**AGENDA
CITY OF CEDAR FALLS, IOWA
PLANNING AND ZONING COMMISSION MEETING
WEDNESDAY, SEPTEMBER 09, 2020
5:30 PM AT CITY HALL VIA VIDEO CONFERENCE**

2. **Central Business District Overlay Design Review – Façade Review for Blue Room Lounge (DR20-004)**
Location: 201 E Main Street
Applicant: Modern Design Architects
Previous discussion: None
Recommendation: *Discuss and recommend approval*
P&Z Action: *Discuss and make a recommendation to City Council*

3. **Site Plan Review – New Cedar Falls High School (SP 20-007)**
Location: 69.6 acre parcel at North of W.27th Street and West of PE Center Drive
Applicant: Cedar Falls Community School District/ Brian Sanderman, INVISION Architects.
Previous discussion: None
Recommendation: *Discussion*
P&Z Action: *Discussion and continue to the next meeting*

4. **Land Use Map Amendment (LUMA) & Rezoning – LUMA from "Office and Business Park" to "Planned Development" (LU20-003); Rezoning from A-1 Agricultural District and R-1 Residential District to MU Mixed Use Residential District (RZ20-002).**
Location: 15 acre parcel, 500 feet north of Huntington Road along the west side of Cedar Heights Drive
Applicant: Oster Family Limited Partnership

1 NORTH ELEVATION
 Scale: 3/16" = 1'-0"

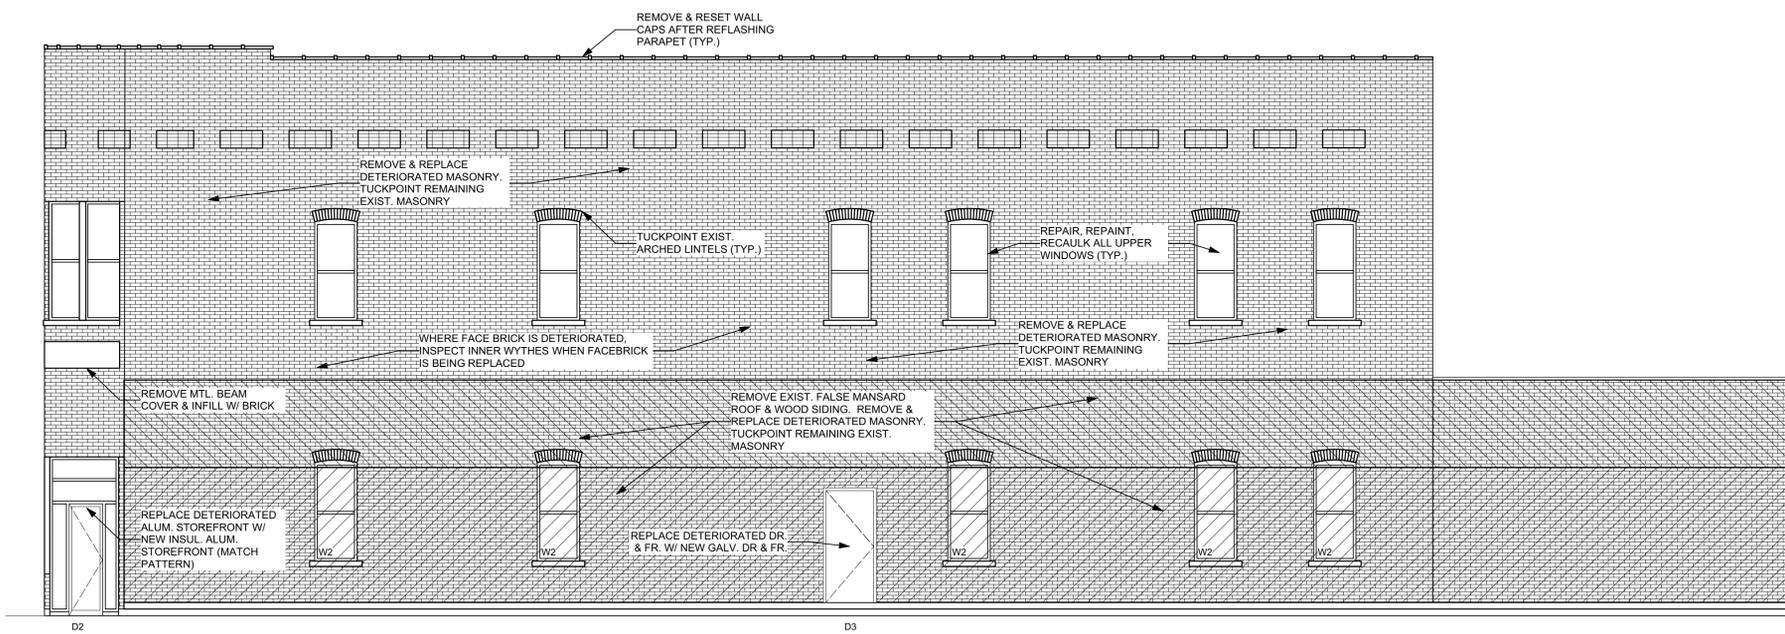
elements (such as cornice lines, awnings and canopies) and vertical elements (such as windows and doors) with the elements of adjacent buildings. Proposed alteration includes removing wooden sheathing and the wood shingle pent roof that runs the full length of the main floor along the north and west façade. This plan is to repair and revive the windows and worn out bricks along both the north and west facades. This proposed alteration would allow the building to resemble the one in year 1958. The proportion of the building will be more rhythmic with brick façade complemented with placement of vertical windows. The proportion of building along the Main Street will remain unaltered, except for a few repairs/replacement of worn out bricks. The proposed alteration of the subject property will be done as per State Historical Preservation Office guidelines and will be uniform with the surrounding buildings. **Criterion is met.**

4. Building Composition: The proposed design must provide visual interest and visually break up long building walls. The existing building composition is being altered by removal of wood sheathing with a projecting wood shingle pent roof that runs the full length of the first floor along the north and west façades. This removal will allow the building façade to take its historical architectural form of the 1950s, making the building composition more balanced and uniform with surrounding buildings. **Criterion is met.**

6. Materials and textures: All material alterations to a building in the CBD overlay zoning district are required to be similar to or compatible with existing materials and textures of buildings in the immediate area. The applicant is proposing to repair/ replace worn out bricks over the north, west and east building facades of the subject property. The proposed alteration project will not include any new materials or textures being added on the building. Rather, the proposal would ensure that the building façade looks more uniform and aligns with the architecture style of neighboring buildings. **Criterion is met.**

PINNACLE PRAIRIE EAST CONCEPT PLAN

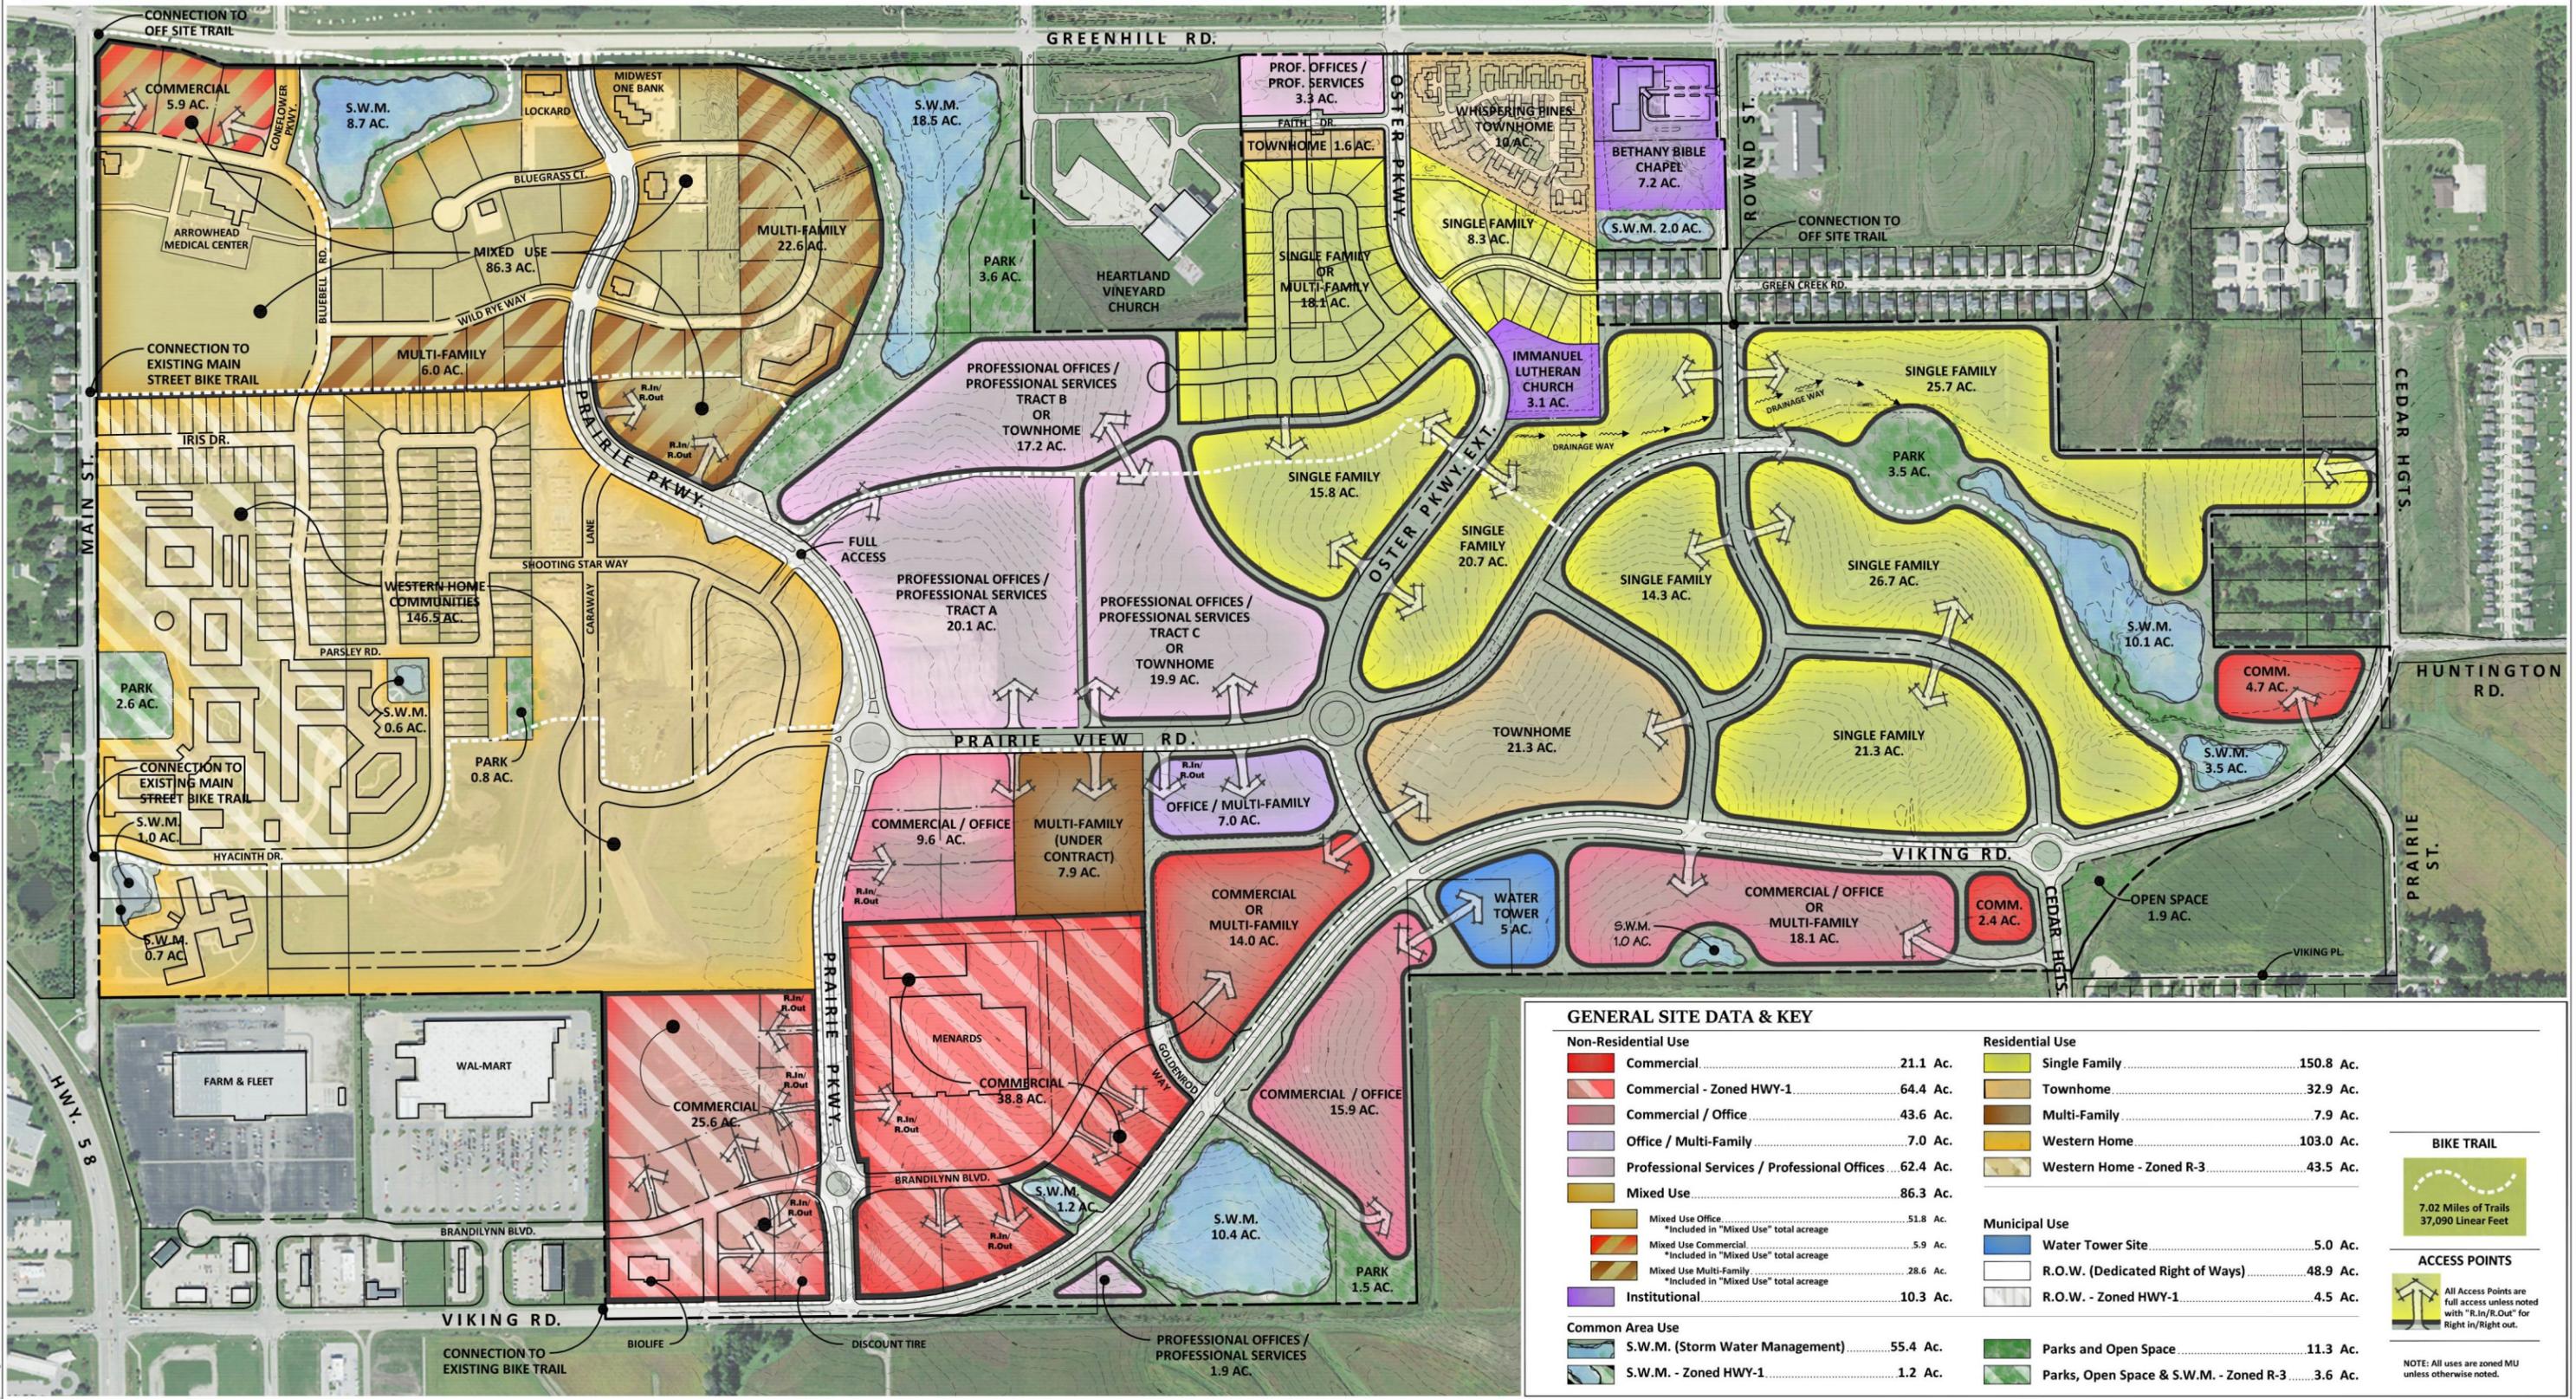
Staff notes that when individual site plans are submitted for review, the placement of the buildings, parking, and open space amenities should be carefully reviewed through the Planning and Zoning Commission and City Council to ensure a high quality living environment for future residents. Multi-family buildings should be oriented toward the street with parking located behind, under, or to the side of buildings and screened with landscaping. Each building should have good access to open space amenities and neighborhood trails.

For townhomes, staff recommends more of a focus on alley-loaded types as shown in the design guidelines as there is a general lack of this housing type in the community and it will reduce the need for extensive driveway curb cuts along neighborhood streets and ensure that these higher density dwellings will fit more seamlessly into the single family residential character of the neighborhood. Staff will continue to work with the applicant to refine the street pattern and access to the townhome section of the master plan. If alley-loaded townhome designs are used there may be more opportunities to integrate townhomes strategically throughout the neighborhood rather than concentrating them in just one large area.

Staff recommends eliminating the cul-de-sac that is labelled as “Court A” by extending it to the east through the multi-family area to Cedar Heights Drive. This would follow the alignment of a farm access road that previously extended across the creek. While there will be additional expense to extend the roadway across Green Creek, the proposed upzoning from Agriculture and R-1 to include a high density multi-family area in place of what was previously shown in the master plan as single family should be sufficient to recapture the cost of this road connection. In addition, determining these costs through platting will provide an opportunity for the developer to set up the deed of dedication to recapture the cost from all the benefited properties, not just the multi-family area.

- Some additional adjustment of the street and alley pattern in the townhome area is needed to ensure adequate traffic circulation.
- The City is in the process of making improvements to Cedar Heights Drive. With that project, adjustments in the right-of-way will be made at the intersection of Huntington Road to allow for a future roundabout, which would allow the street to be extended to the west to serve the commercial area and any additional development proposed in the future to the existing lots that were created behind the homes in the Ideal Acres subdivision along Cedar Heights Drive. While currently these lots are owned and used as extended yard areas for these homes, there would be the potential for additional homes to be developed if a means of access is provided. There are a number of possible
